Laurel Park Tennis Center Site Improvements

Addendum # 2

January 28, 2013

EXHIBIT A (revised 1/28/13)
REVISED DRAINAGE @ SEATING AREA "D"
NOT TO SCALE

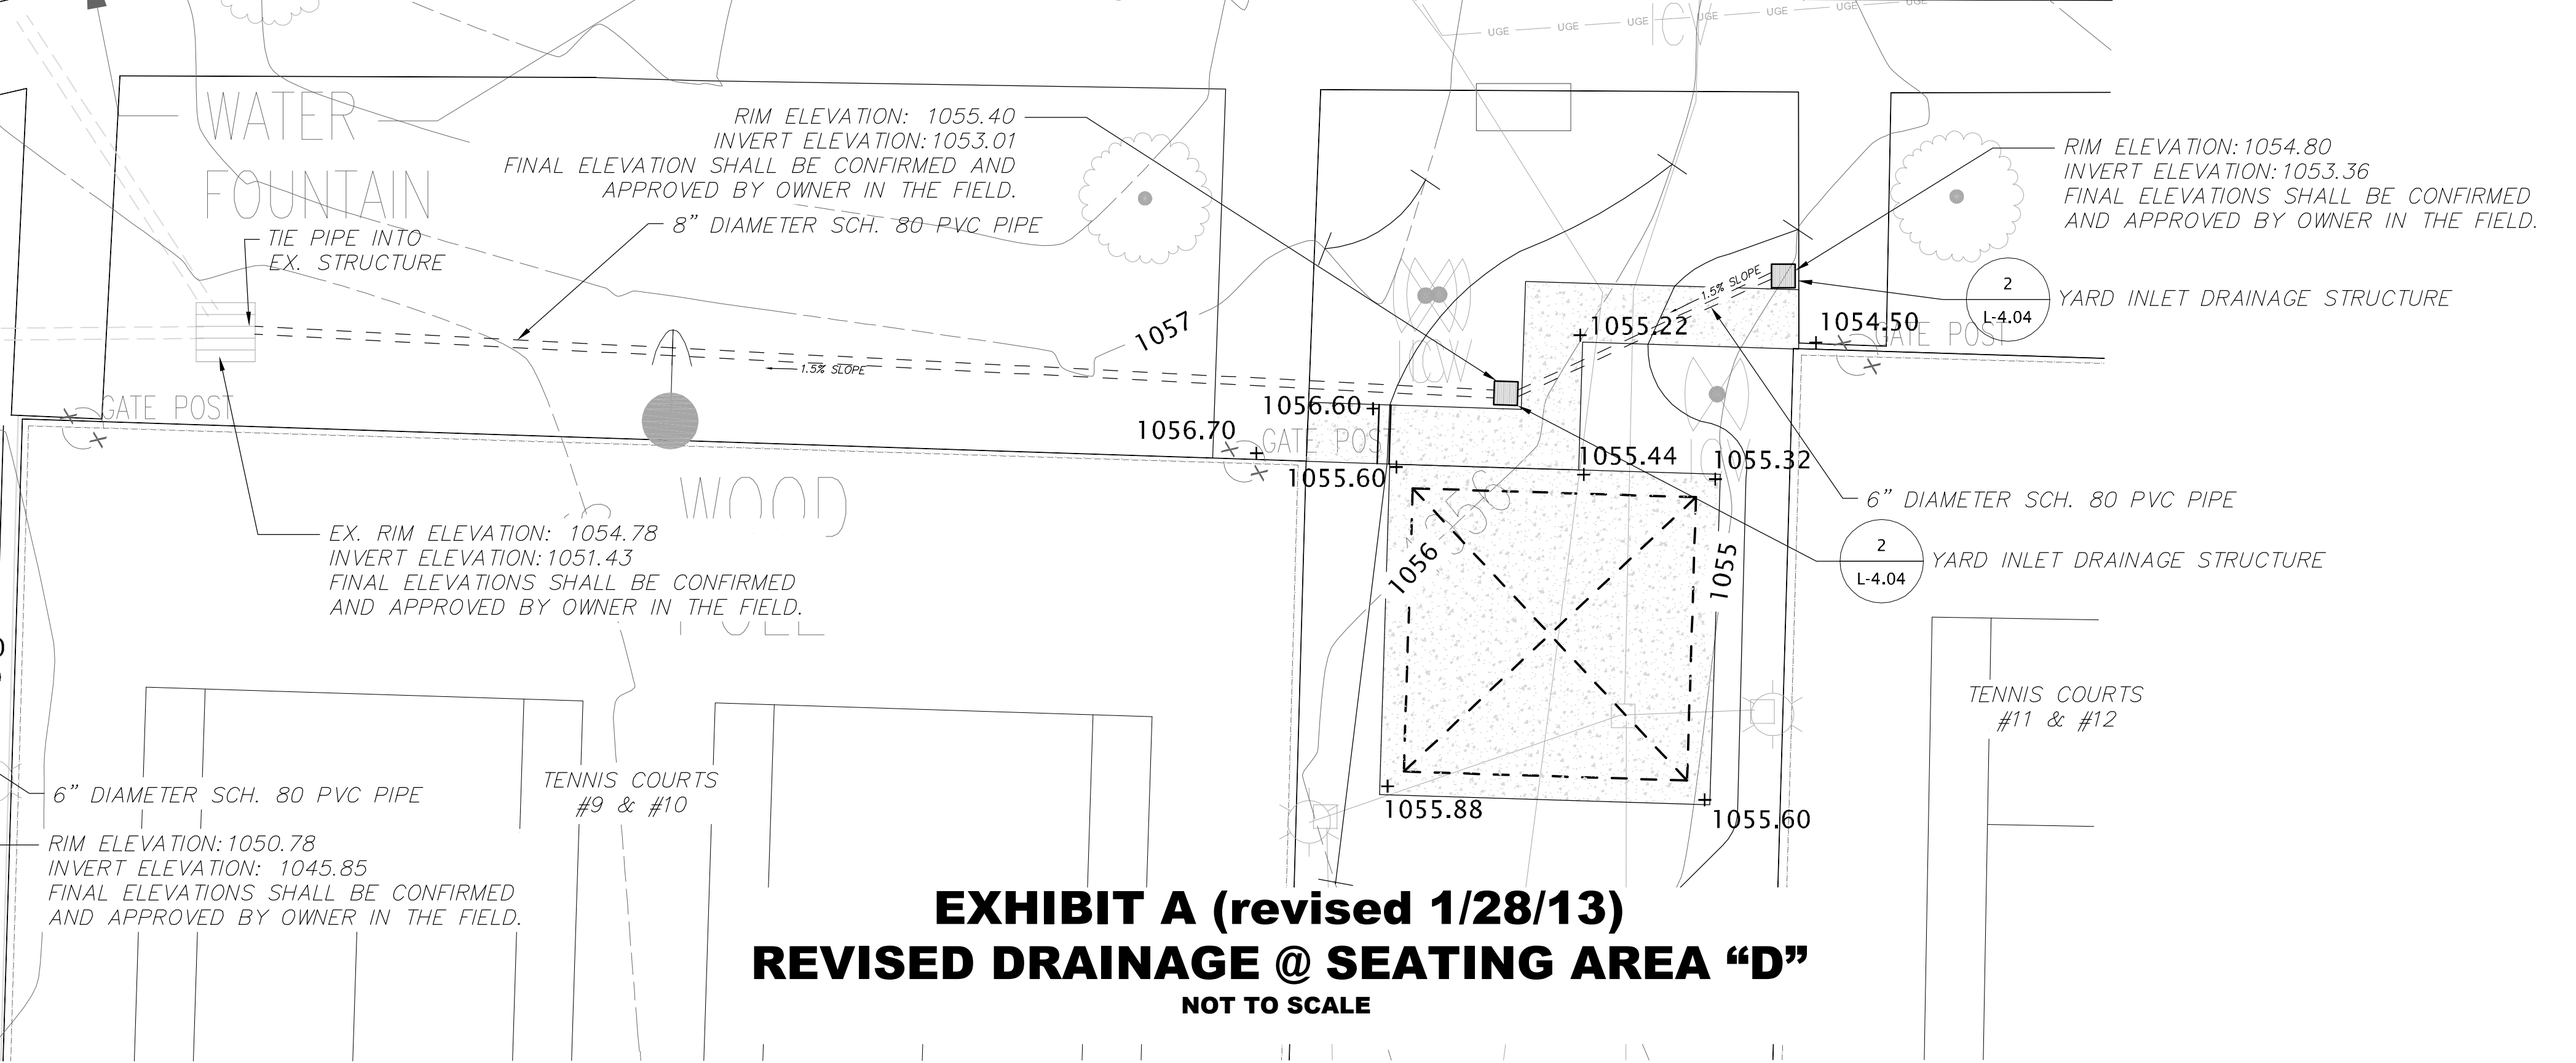
1. Addendum 1 Exhibit A: The profile of the drain line that was revised appears to be assuming that water will flow up hill. Is that your intent? *See Exhibit A revision, attached.*
2. Rubber Surfacing at Seating Ares B: There appears to be a discrepancy between the plans and what the manufacturer is recommending; specifically the thickness of the rubber material (1-1/2" manufacturer / 4" Detail 4 sheet 4.04): *Follow manufacturer recommendation of 1-1/2 "*
3. Will the Tennis Center remain open during Construction? *Yes*

A. Exhibit A (Revised per item 1 above)
